1875 WESTLAKE DR  
NORRIS BOAT DOCK

SP-2020-0223DS

# **VARIANCE REQUEST**

## **VARIANCE RECOMMENDATION**

Canyon  
Rimrock

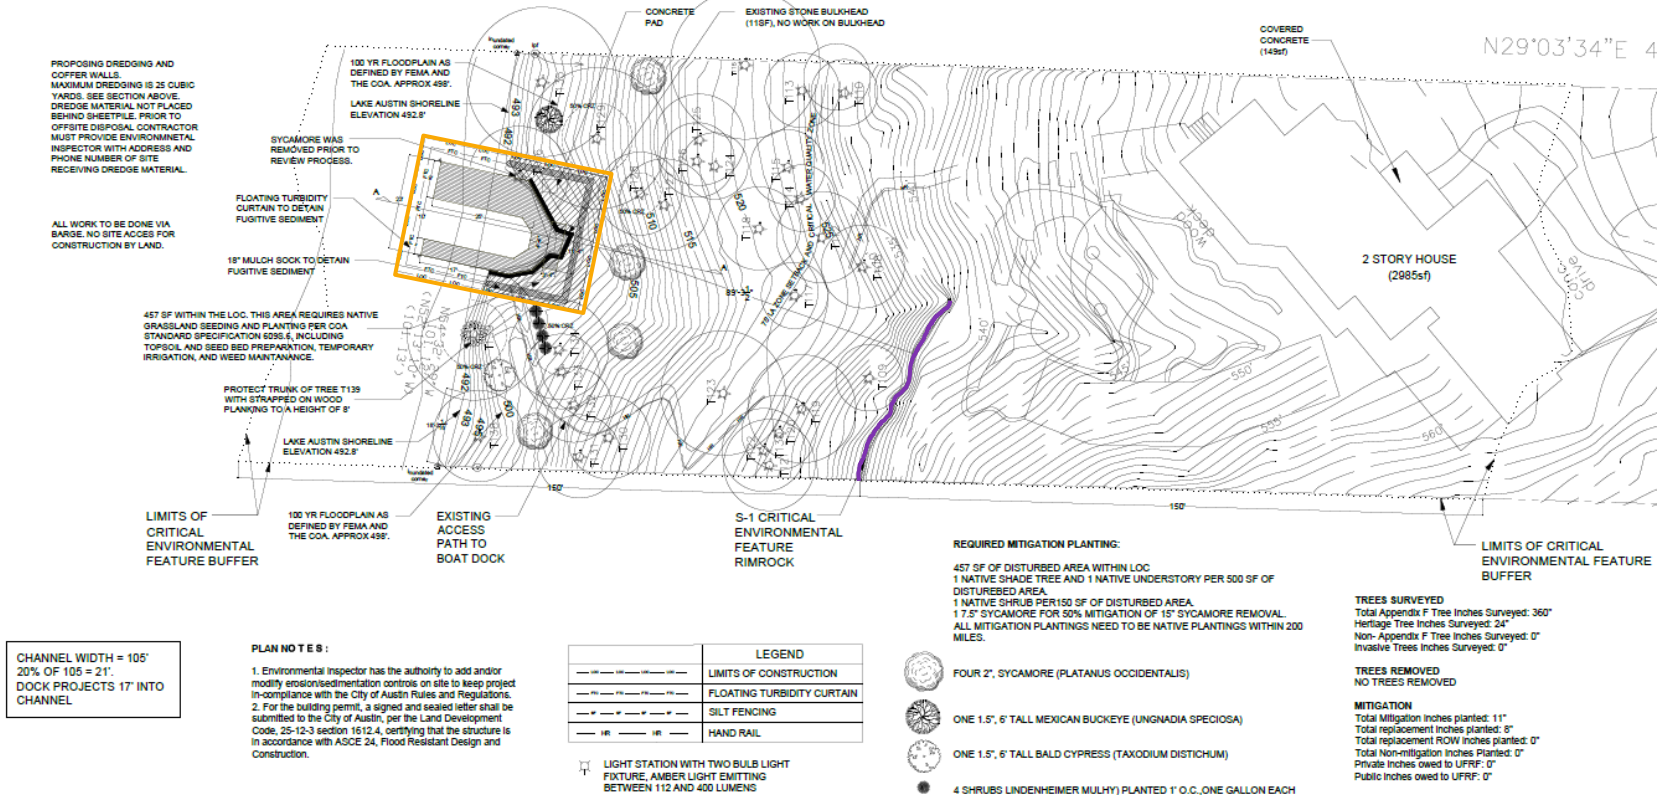
Rimrock extends  
onto neighboring  
property

- Dock construction is proposed at bottom of slope, with Limits of Construction (orange) as far from Rimrock CEF (purple) as is feasible.
- No new shoreline access is proposed between house and new dock.

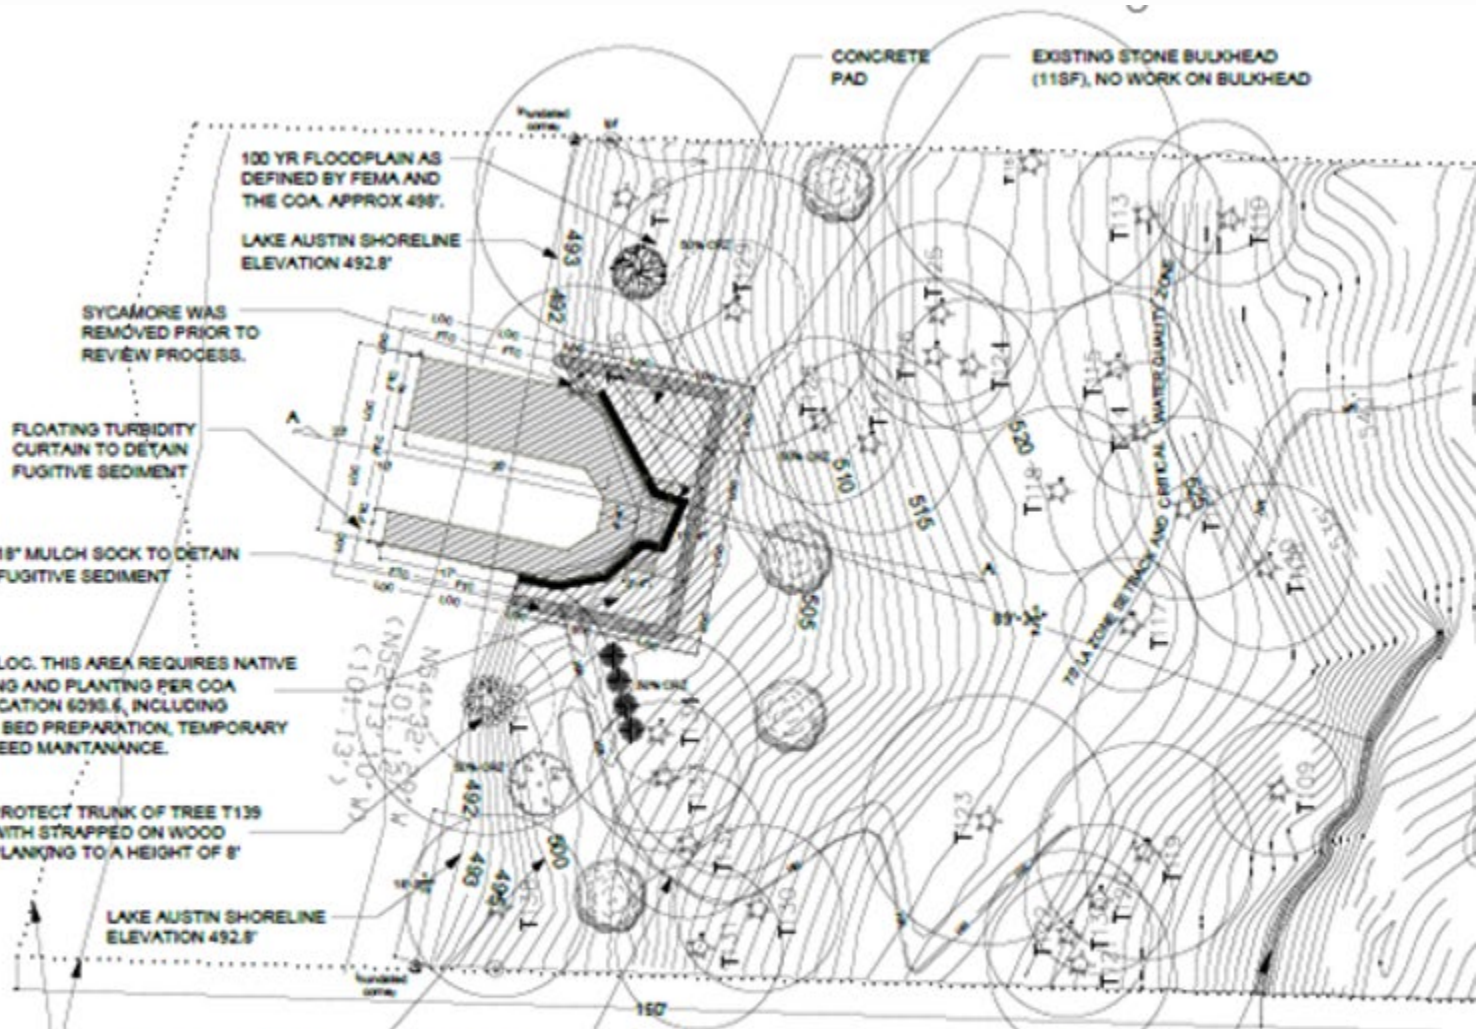
PROPOSING DREDGING AND COFFER WALLS. MAXIMUM DREDGING IS 25 CUBIC YARDS. SEE SECTION ABOVE. DREDGE MATERIAL NOT PLACED BEHIND SHEETPILE. PRIOR TO OFFSITE DISPOSAL CONTRACTOR MUST PROVIDE ENVIRONMENTAL INSPECTOR WITH ADDRESS AND PHONE NUMBER OF SITE RECEIVING DREDGE MATERIAL.

ALL WORK TO BE DONE VIA BARGE. NO SITE ACCESS FOR CONSTRUCTION BY LAND.

457 SF WITHIN THE LOC. THIS AREA REQUIRES NATIVE GRASSLAND SEEDING AND PLANTING PER COA STANDARD SPECIFICATION 609S.6, INCLUDING TOPSOIL AND SEED BED PREPARATION, TEMPORARY IRRIGATION, AND WEED MAINTENANCE.

PROTECT TRUNK OF TREE T139 WITH STRAPPED ON WOOD PLANKING TO A HEIGHT OF 8'

SYCAMORE WAS REMOVED PRIOR TO REVIEW PROCESS.

STAFF RECOMMENDS THE APPROVAL OF THIS  
VARIANCE WITH THE CONDITION THAT ALL  
CONSTRUCTION BE COMPLETED BY BARGE.
